Agenda
Crowley City Council
August 20, 2026
Work Session - 6:30 PM

2. Discuss and consider approval of a preliminary plat for Karis Addition Phase 2A, an approximately 39.6 acre development located in the F. Wells Survey, Abstract Number 1683, the T. Toler Survey, Abstract No. 1536, and the M. Walters Survey, Abstract No. 1598, City of Crowley, Tarrant County, Texas. **Case # PPLT-2026-005.**

Planning Staff Review Comments

Submittal #:	2 (modified)		
Reviewed by:	Rachel Roberts	Date:	7.27.26

Image from previous version of preliminary plat. Floodplain shown in pink; existing Karis development shown in blue; phase 2 shown in white.

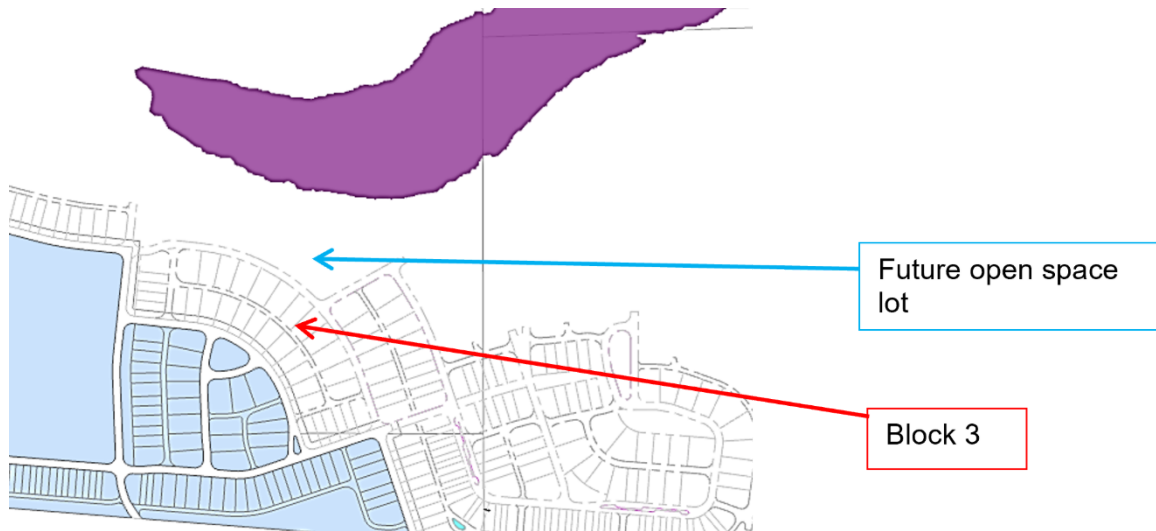
Block 3: Staff recommend granting the variance for this block.

This block faces a future open space lot that abuts the floodplain. No roadways are planned to go through the open space or floodplain, so a roadway added to break up this block would end here.

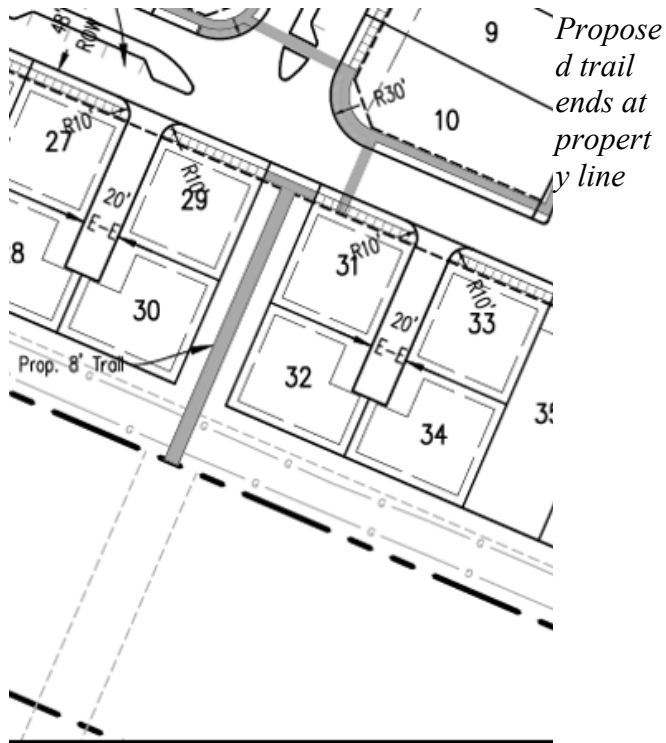
Block 5: The previous version of Phase 2A offered more connectivity on the east side of the phase; roadway connectivity was reduced to allow for the revised lot and block layout. Providing a trail (pedestrian/bicycle) connection to the phase to the south will increase connectivity overall for the phase, and staff support the block length variances in this area on the condition the trail easement is granted by Oncor.

The property to the south of this block is Oncor-owned property, and a gas pipeline easement runs behind the lots within the Karis property. The developer would not be able to add a roadway connection through those areas. A railroad runs to the east of the property, and the developer would not be able to make any roadway connections there.

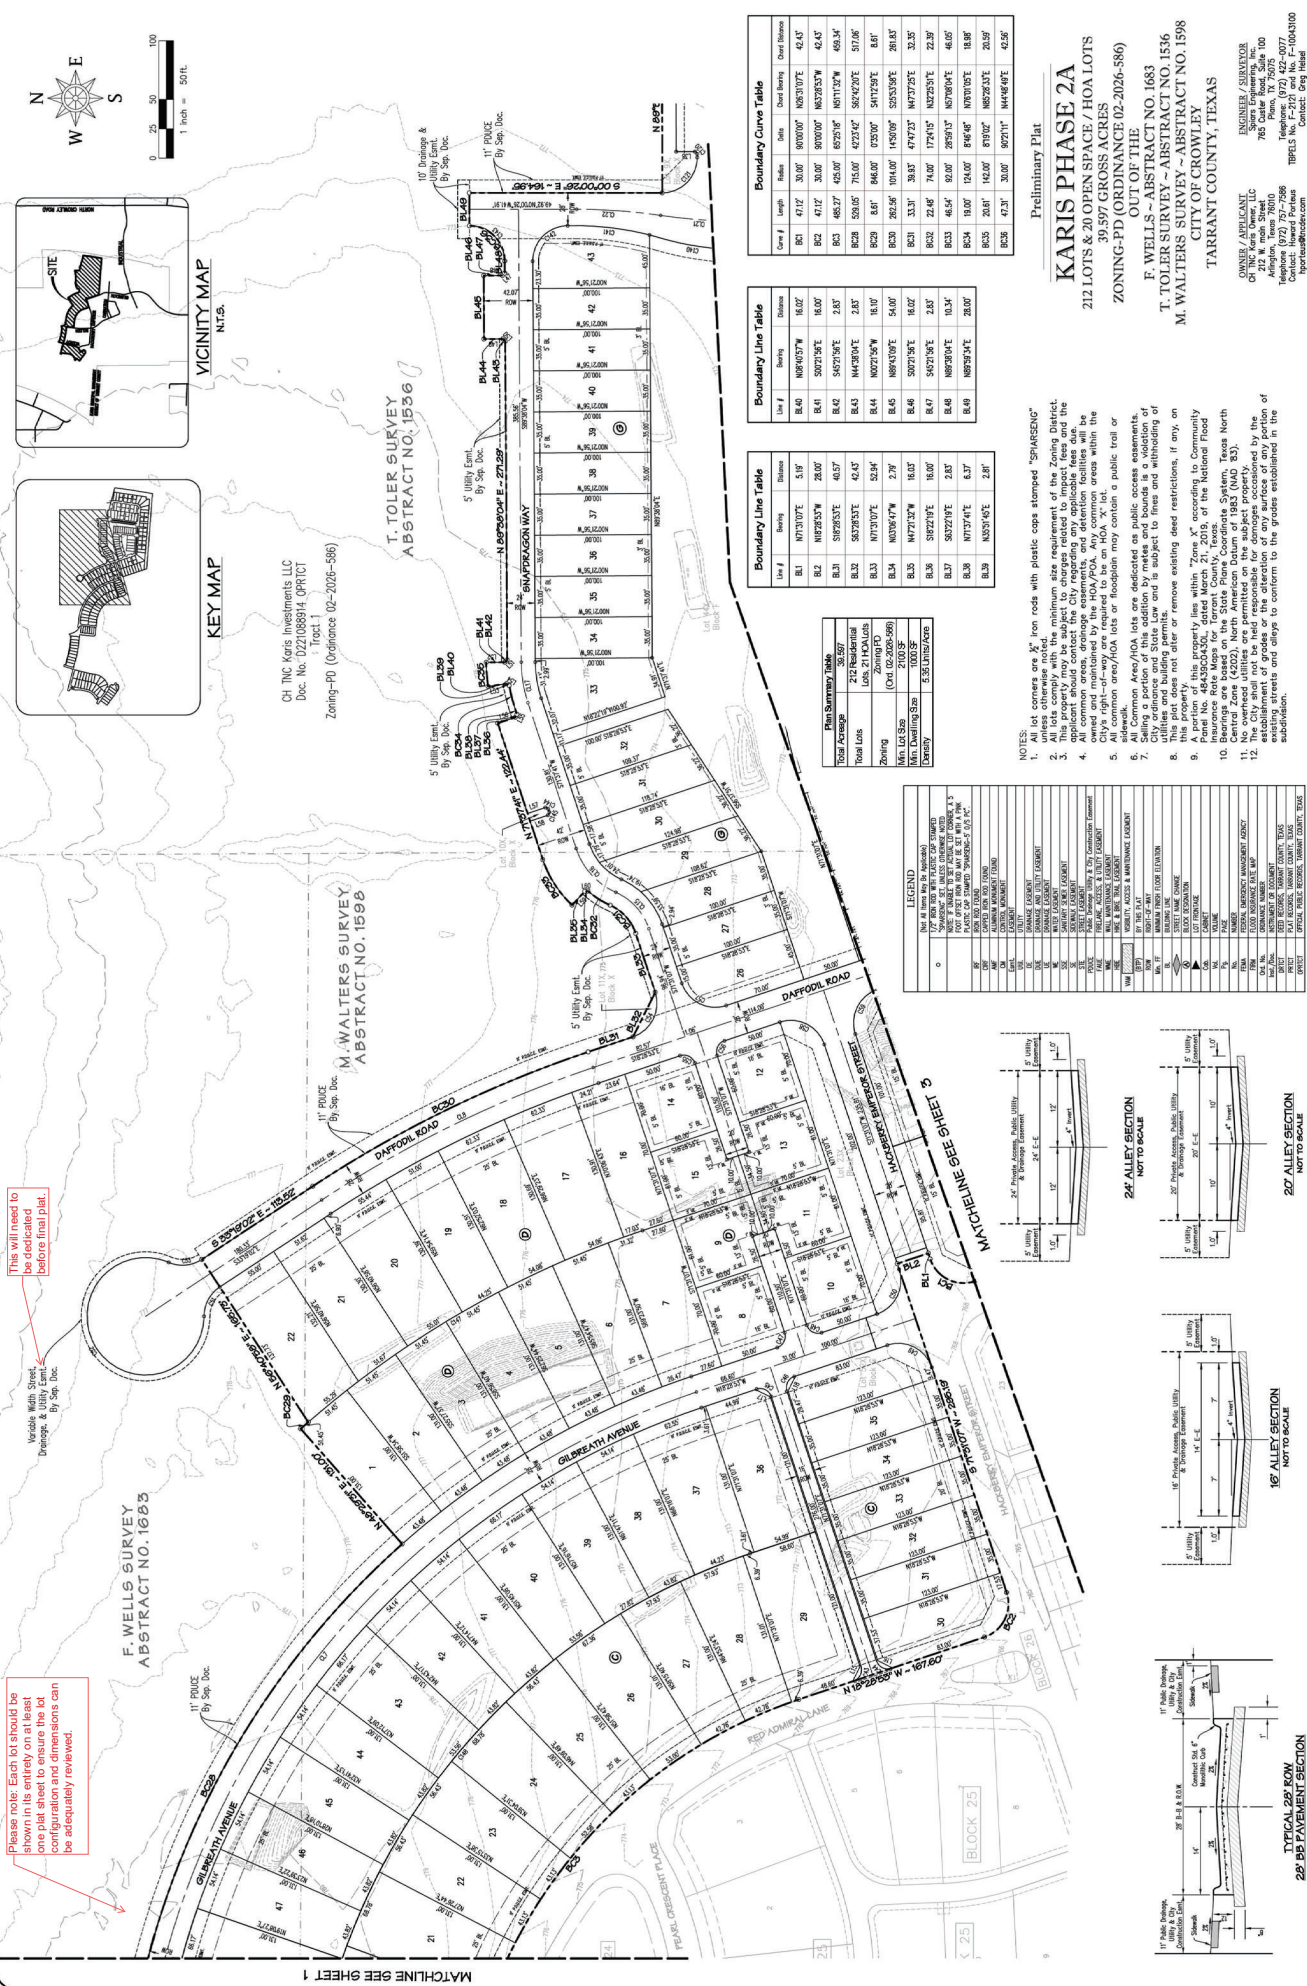
This will need to be dedicated before final plat.

Please note: Each lot should be shown in its entirety on at least one plat sheet to ensure the lot configuration and dimensions can be adequately reviewed.

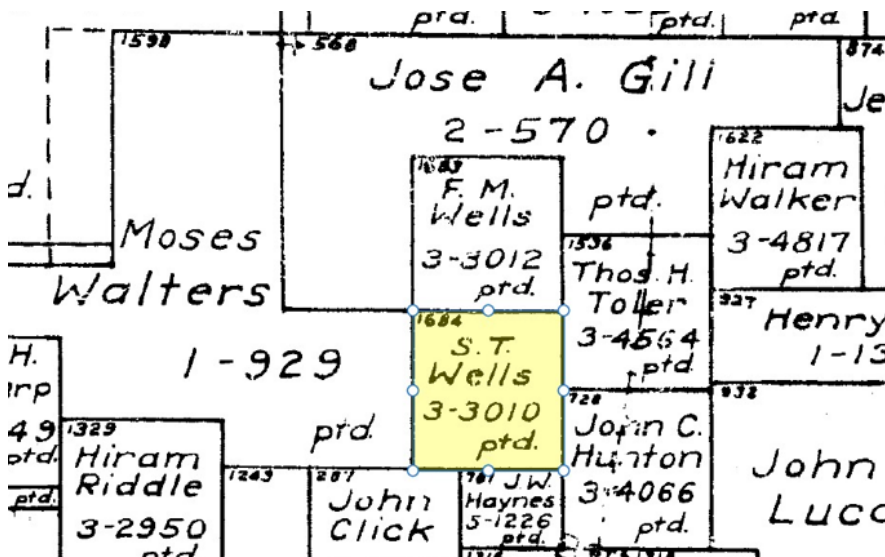
1. List all lots and blocks in the title block.

RESPONSE: *Lots and blocks have been added to the title block of each plat sheet.*

STAFF RESPONSE: Addressed.

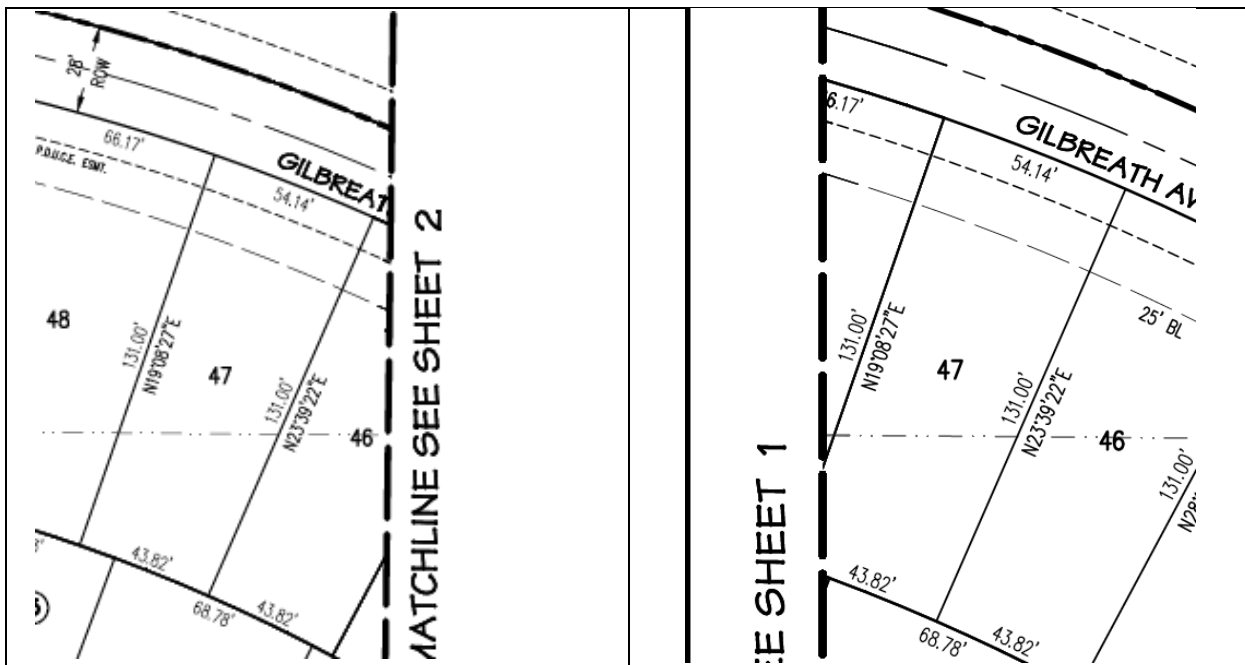
5. Please show the lot and block numbers for open space lots more clearly, particularly for the lots that are not located in the ROW. They are grayed out to an extent that they are hard to read.

RESPONSE: 'X Lot' labels updated to be darker and more legible.

STAFF RESPONSE: Addressed.
